Comment Letter I79

Response to Comment Letter I79

Laura Felten
February 18, 2014

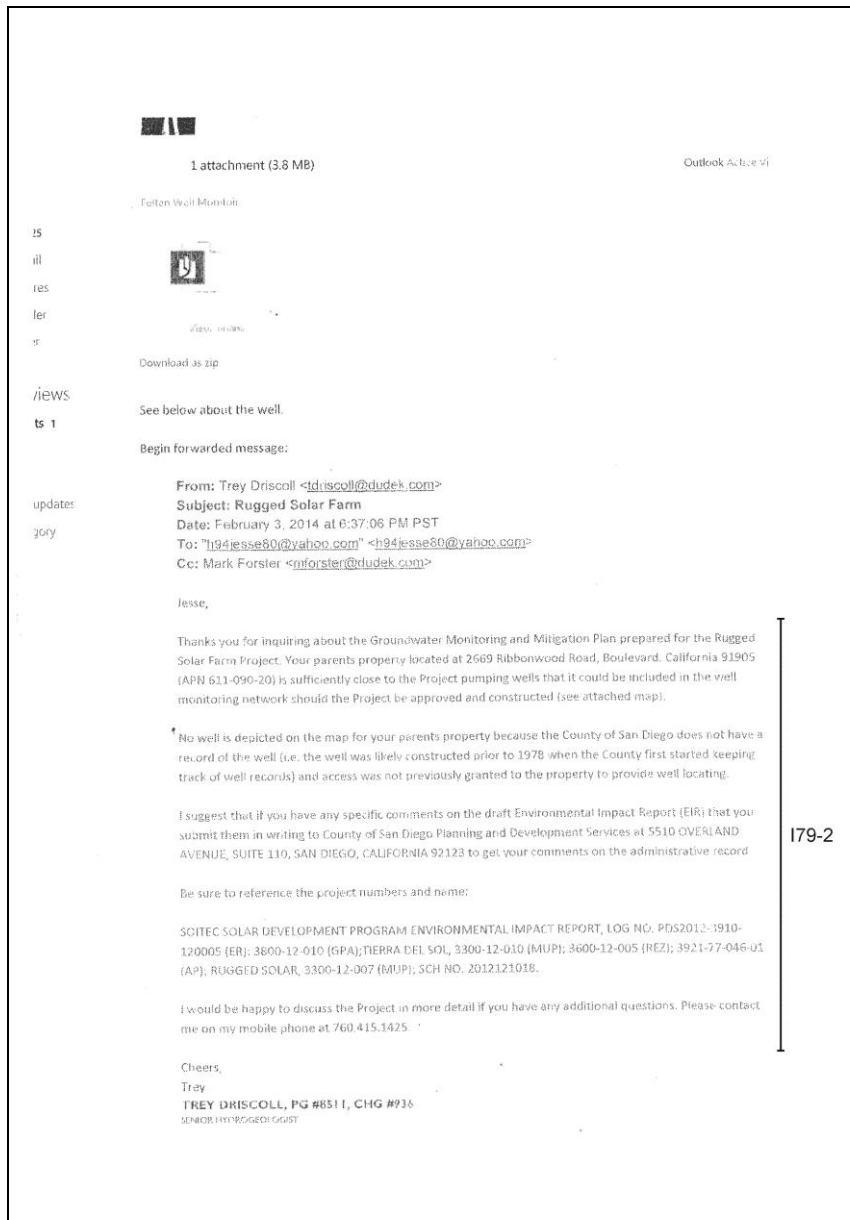
The question I have is regarding page #8 on the report and I have attached a screen shot below. I believe there is an open residential well that is not reflected on the layout. There is no well noted for 2669 Ribbonwood Rd, Boulevard, CA 91905 which has parcel #611-090-20-00. The east edge of the property shares a border of the solar project's property line. The well is not depicted by any color dot and I believe it is located within the 1/2 mile radius of project well 6b. The well in question is located just south of the Walker Residence Well which is 2708' from well 6b according to your layout. Is there a reason why this well was left off or was it an oversight?

I79-4 This is an attachment of well locations identified in the groundwater study and the location of the well for the property at 2669 Ribbonwood Road, Boulevard, CA (APN 611-090-20). See response to comment I79-1 above.

Please refer to response to comment O10-23, which discusses the Groundwater Mitigation and Monitoring Program that will be implemented during construction and operation of the Proposed Project, per Mitigation Measure M-BI-PP-15. Please also refer to Appendix 3.1.5-6 (Table 3-20) which lists drawdown estimates by distance and duration of pumping. The commenters well (as depicted on the image attached to the comment letter) is located approximately 0.5-mile (2,640 feet) from Well 6b and based on the information provided in Table 3-20, projected drawdown would be less than significant based on County of San Diego well interference thresholds (see Section 1.3 of Appendix 3.1.5-6). For the Tierra del Sol Solar Farm, all wells to be monitored are listed in the GMMP, which are available for review on the County's administrative record for the Proposed Project. The administrative record for the Proposed Project can be found online at http://www.sdcounty.ca.gov/pds/ceqa/SOITEC_SOLAR_DEVELOPMENT_ADMINISTRATIVE_RECORDS.html. For the Rugged Solar Farm, all wells within 1/2 mile of the Project site are eligible to be included in the monitoring program.
